Commonwealth Edison

June 20, 1984

Subject: Byron Generating Station Units 1 and 2
Technical Specifications
NRC Docket Nos. 50-454 and 50-455

Attachments A through J to this letter contain marked-up pages of various sections of the Technical Specifications. A summary explanation of the changes is provided for each attachment. Justifications are provided where appropriate.

FIGURE 3.2-3 N-LOOP OPERATION FLOW VS. F_{OH} LIMIT. CYRON 100000

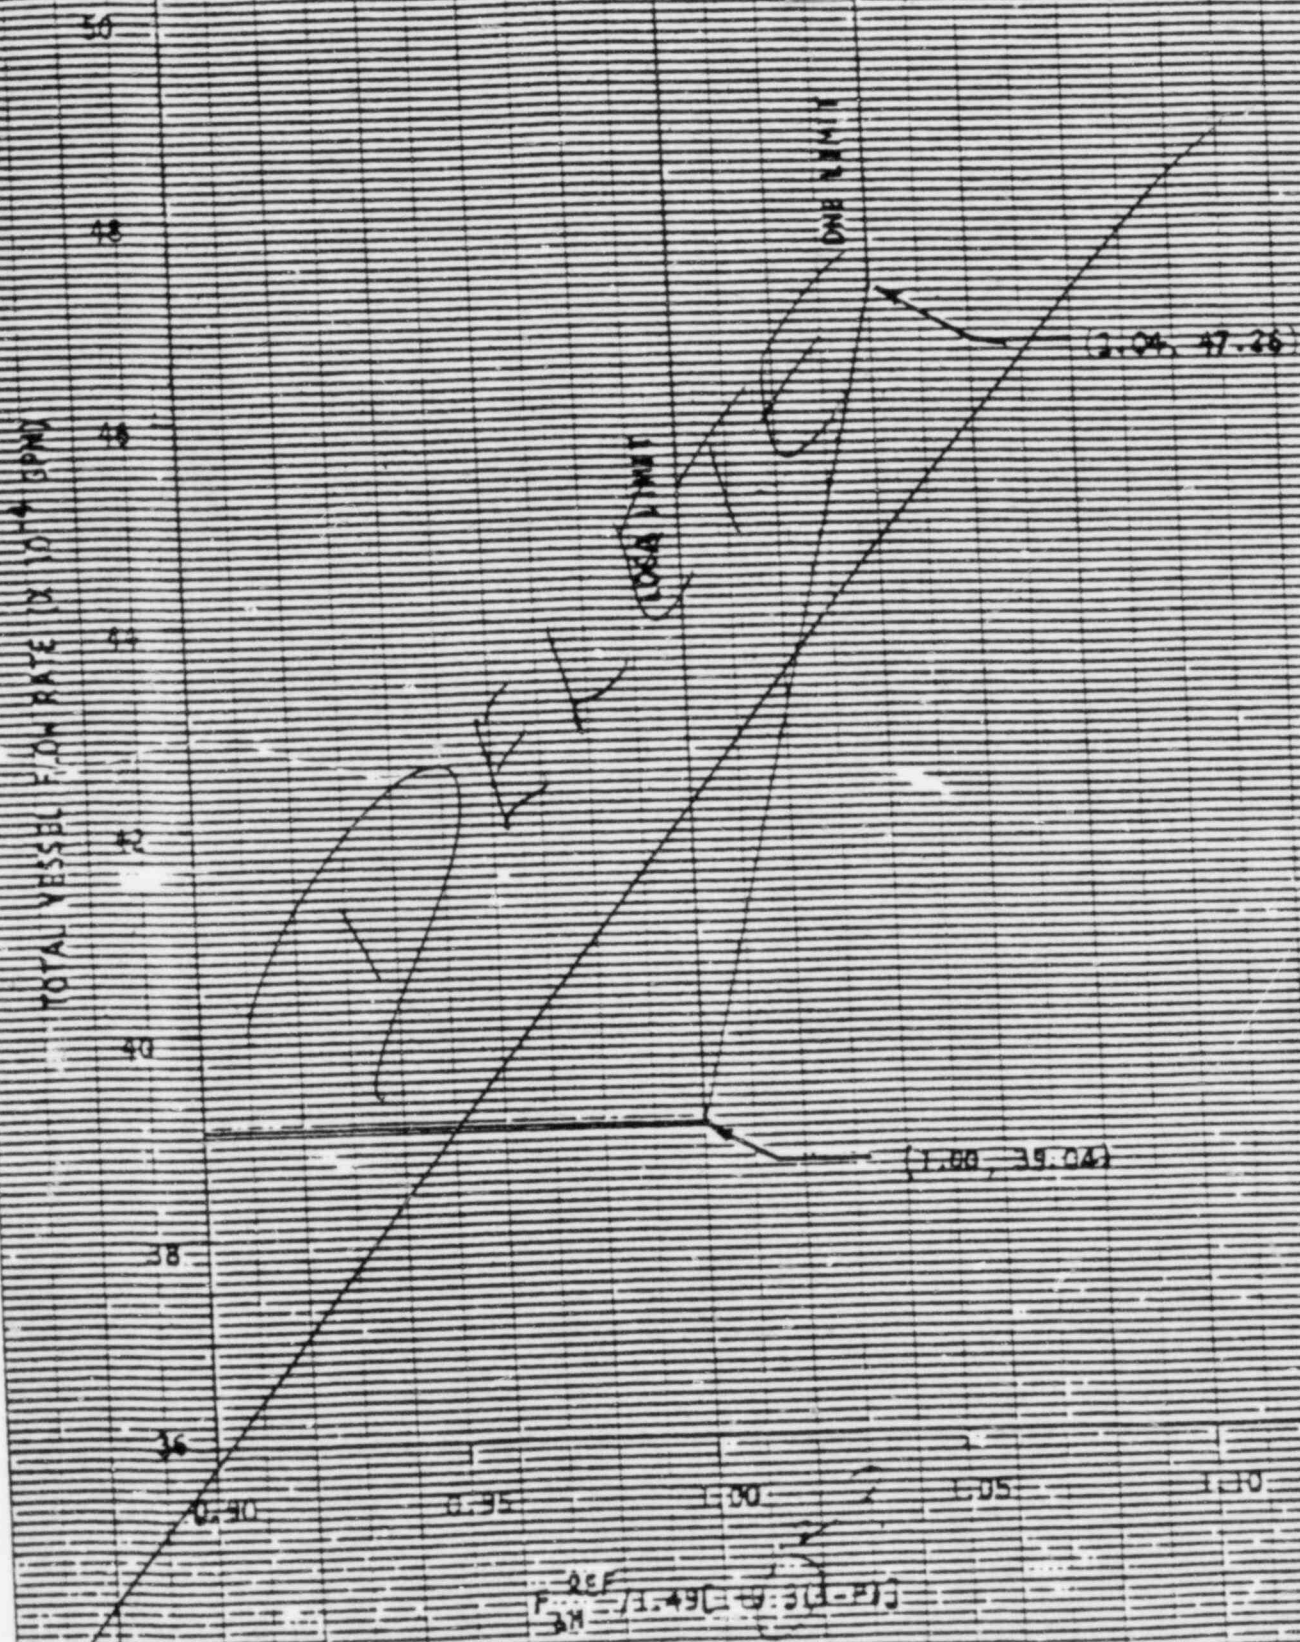
Delete "shown on Figure 3.2-3".

Delete Figure 3.2-3

Delete the words "operation shown on Figure 3.2-3."

Since there is no rod bow penalty, Figure 3.2-3 (pg. 3/4 2-9) could be simplified and described by a rectangle. The proposed change to the LCO Section 3.2.3 incorporates the requirements of Figure 3.2-3; therefore, the figure we've previously submitted can be deleted.

Delete the original LCO and replace with "3.2.3 Indicated Reactor Coolant System (RCS) total flow rate and F_{Δ}^N shall be maintained as follows:

a. RCS Total Flowrate \geq 386,000 GPM

b. $F_{\Delta}^N \leq 1.55 [1.0 + 0.3 (1.0-P)]$

2.3 Indicated Reactor Coolant System (RCS) total flow rate and $F_{\Delta H}^N$ shall be maintained as follows for four loop operation.

a. RCS Total Flowrate $\geq 386,000$ GPM

b. $F_{\Delta H}^N \leq 1.55 [1.0 + 0.3(1.0 - P)]$
